P&Z STAFF REPORT

Board of Appeals Meeting, August 11, 2020

Case: **V20-0027 – 801 Mount Paran Road**
Staff Contact: Madalyn Smith (msmith@sandyspringsga.gov)
Report Date: July 22, 2020

Request for a Variance from Sec. 9.2.4.A to allow encroachment into the 50-foot undisturbed natural vegetative buffer (50-foot buffer) and the additional 25-foot impervious surface setback (25-foot setback) for an addition to an existing home and minor site improvements.

PROPOSED
OVERALL SITE
EXHIBIT

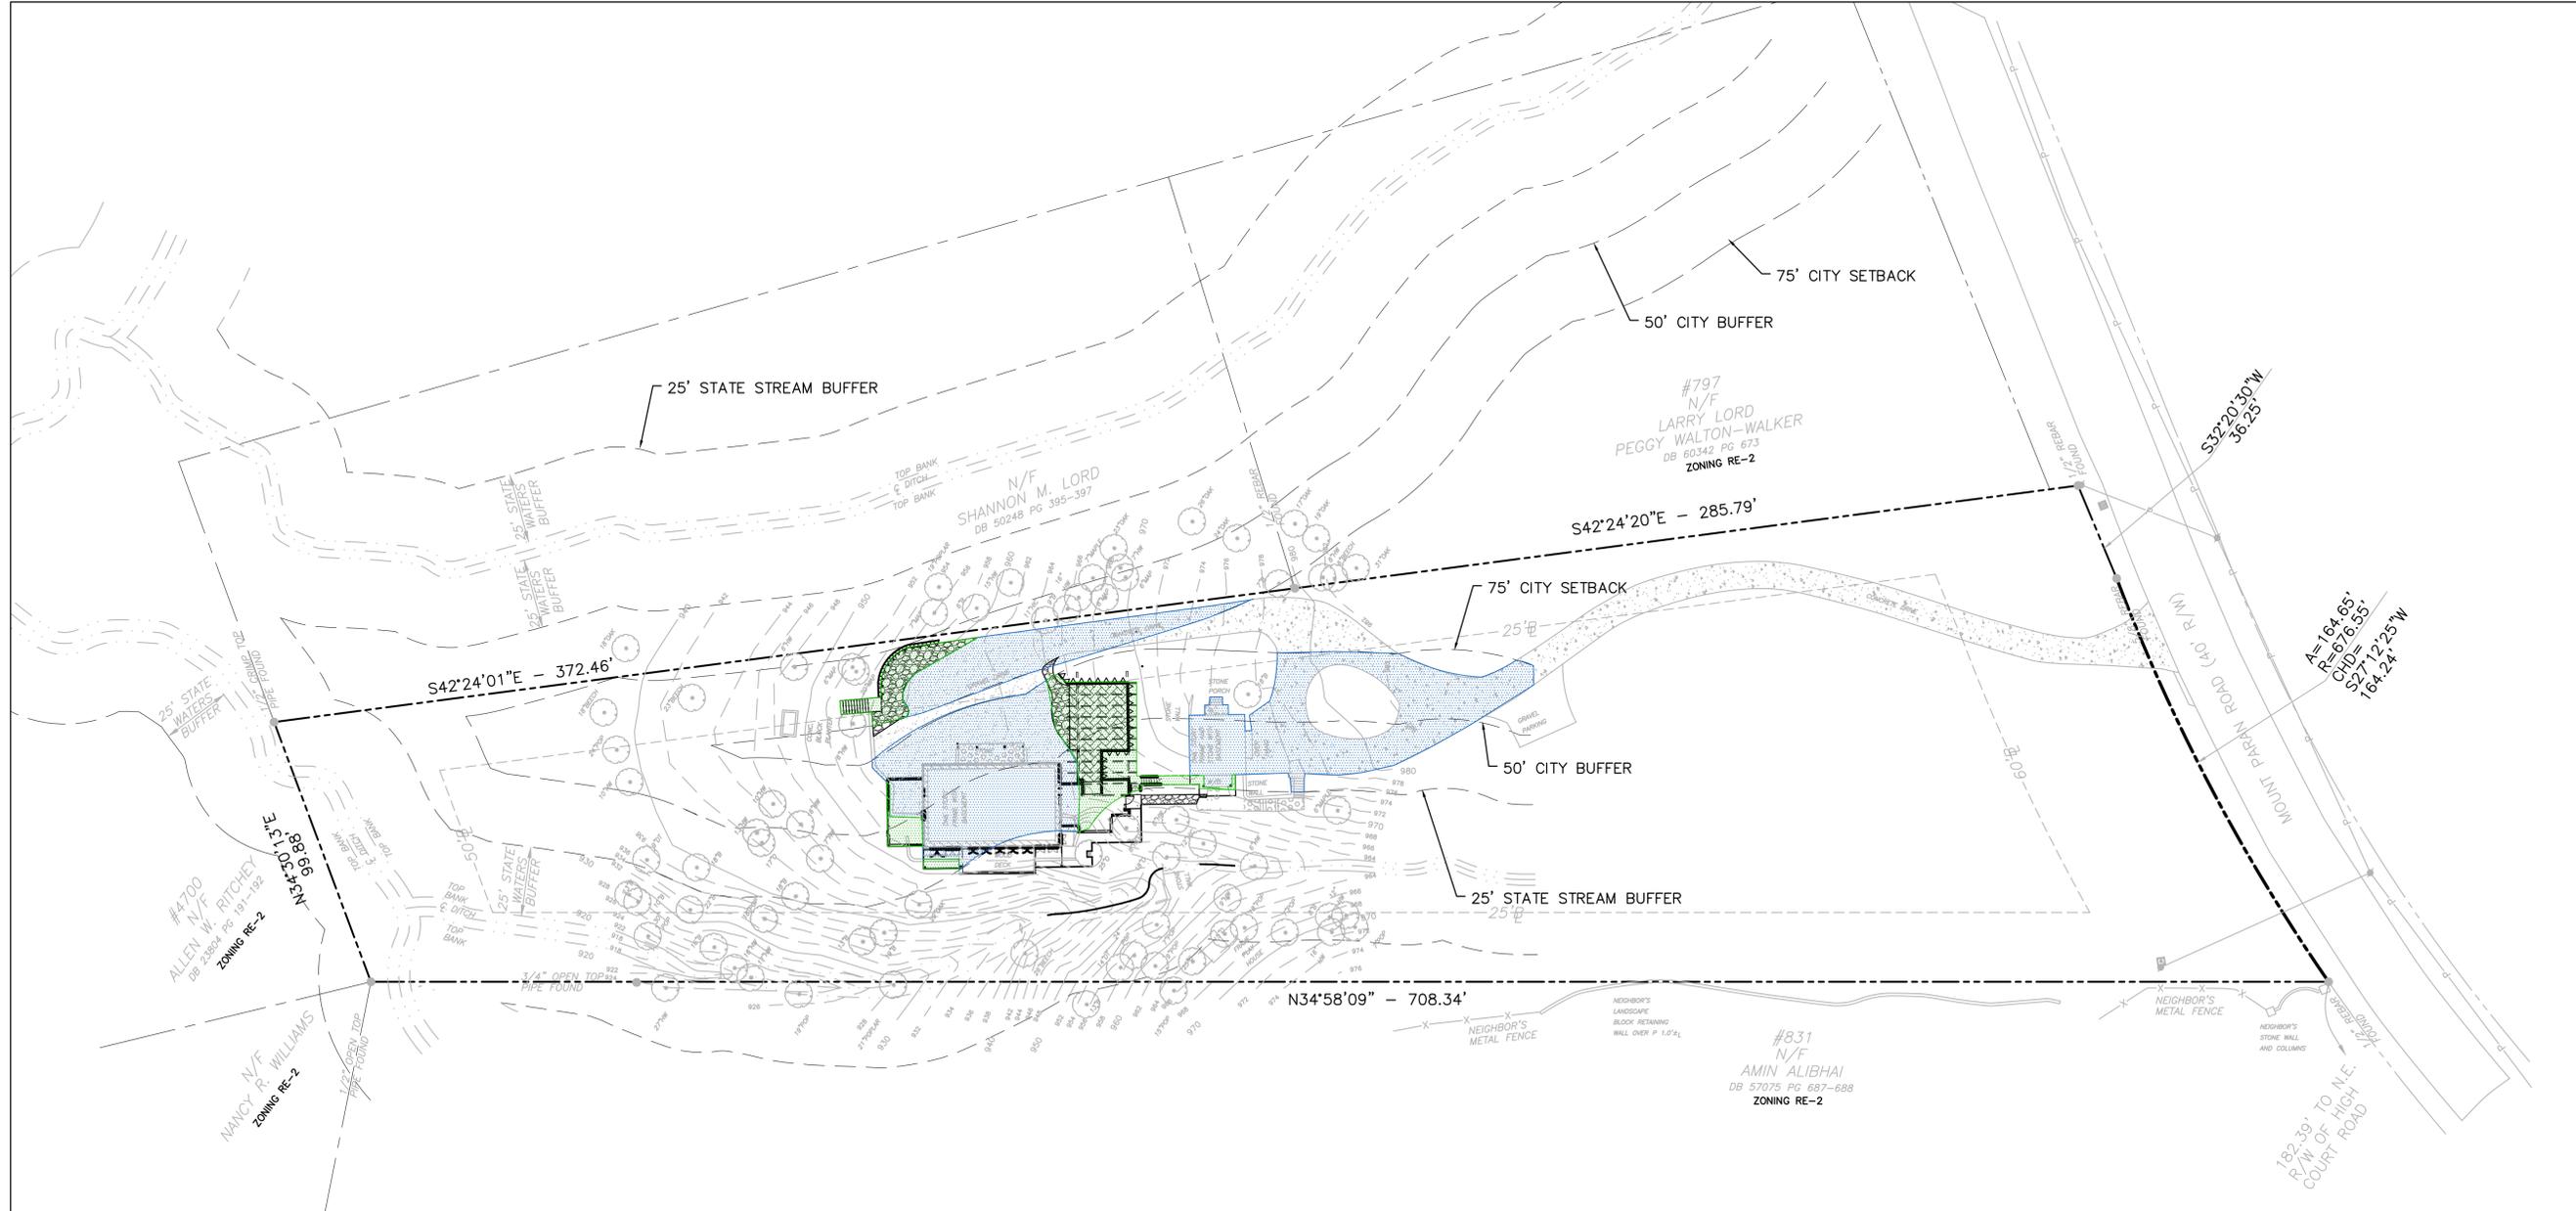
Finding: The entire home and accessory studio are located within two converging stream buffers so there is no alternative that accomplishes the goals of the homeowner that do not encroach into the buffers.

However, due to the nature of the topography, the improvements made to the home would be on piers, which greatly reduces the negative impacts of the intrusion. It is Staff's belief that there would be minimal disturbance and the tree canopy and vegetation of the buffers can be adequately maintained. The applicant is also proposing improvements to stormwater mitigation through the use of a stormwater collection and reuse tank.

I've [reviewed] this and, assuming it is acceptable on other respects, it isn't anything that will have any design standard issues, especially since all of the existing construction is over 100 yards from the street and not visible and all the new construction is behind or beside existing.

It does also appear that the engineer's contention is correct that this design will minimize site disturbance during construction and throughout its life cycle. The topography is very challenging and this concept seems to meet the City's goals of eliminating mass grading and other significant alterations to natural topography, as we have seen with many other residential properties in the City.

There really isn't any way to add onto these structures without encroaching into these setbacks and these additions seem to be the minimum expansion any owner would need to bring the property to a level of current residential functionality and to address their son's accessibility needs.

1. The encroachment be limited or substantially similar to that shown on the "*Proposed Overall Site Exhibit*," prepared by Contineo Group, dated May 28, 2020, received July 10, 2020
